- From: Jackie Chow (jchow23708@yahoo.ca)
- To: mbaski@mapleridge.ca
- Cc: cgoddard@mapleridge.ca; mhalpin@mapleridge.ca; cneufeld@mapleridge.ca
- Date: Sunday, June 19, 2022, 02:14 p.m. PDT

I have two comments with regard to this development proposal:

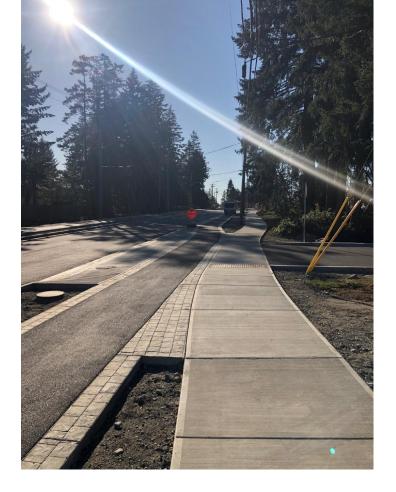
According to the North East Albion Concept Plan, bike lanes are planned along 112 Ave. For safety, I would love to see a design of the driveway entrance to this development as shown in the first picture below (Nanaimo). This design clearly indicates to drivers that people cycling and walking have the right of way
